# MEMORANDUM

**From:** Chief Officer Environment & Technical      **To:** Chief Officer Planning & Regulatory  
**Our Ref:** ET/DC/P/2018/1063      **Your Ref:** MRJ/P/2018/1063  
**Date:** 11<sup>th</sup> July 2019

**Location:** O. S Grid Ref: 350 545 Land West of Bryn Isa, Vicarage Lane, Gresford, Wrexham.

**Development:** Proposed residential development for 44 no. residential dwellings (of which 25% - 11 no. will be affordable ), public open space, landscaping, means of highway and pedestrian access, local highway and pedestrian infrastructure improvements along Vicarage Lane, foul sewerage pumping station and new off-street parking provision for existing residents.

- 7.5t Panel Van
- Overall Length 7.210m
- Overall Width 2.192m
- Overall Body Height 2.544m
- Min Body Ground Clearance 0.316m
- Track Width 1.865m
- Lock to Lock Time 4.00s
- Kerb to Kerb Turning Radius 7.400m

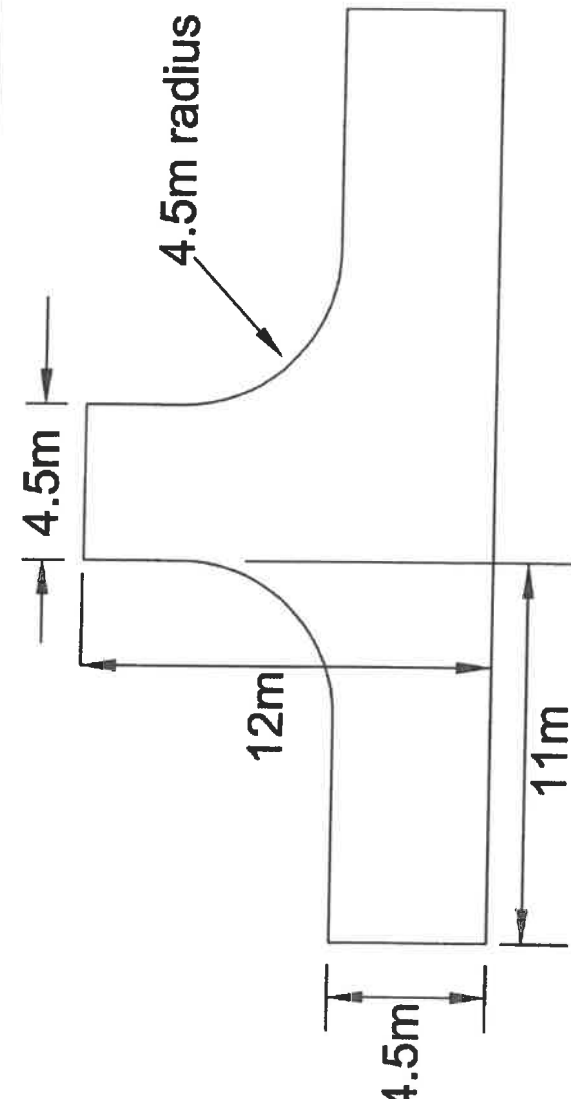
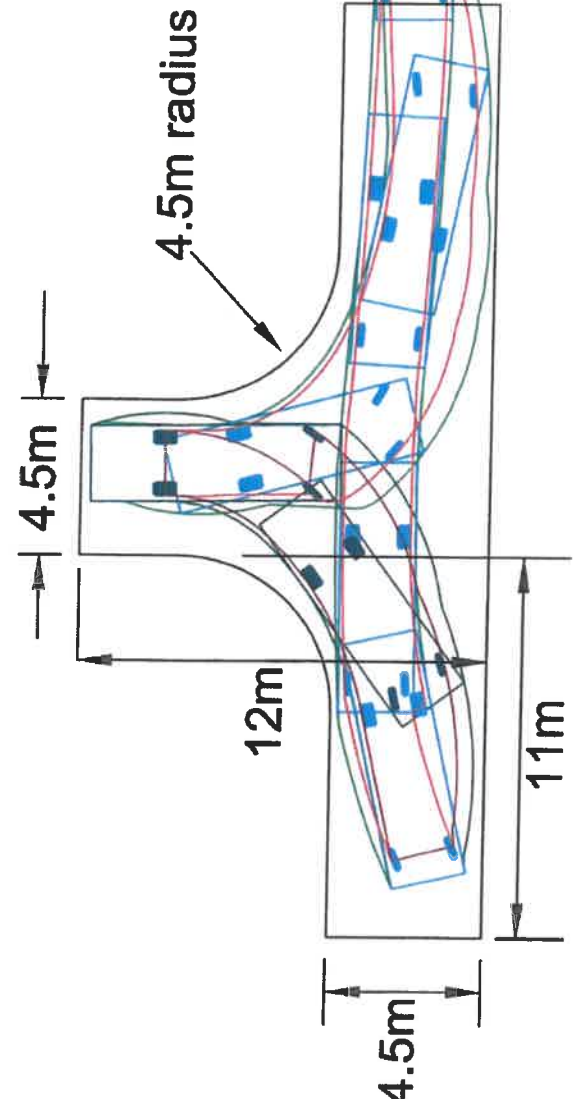
Indicates a 3.5T Panel Van turning within the access road serving plots 1 – 8. I would recommend that a suitable turning head is provided to accommodate the turning movements of a medium sized delivery vehicle (see attached detail) eg/ Tesco delivery van. Deliveries along the frontage of Vicarage Lane should be avoided as cars already park on the opposite side of the road (ie/ existing residents).

Please ask the applicant to provide an amended layout plan indicating this detail.
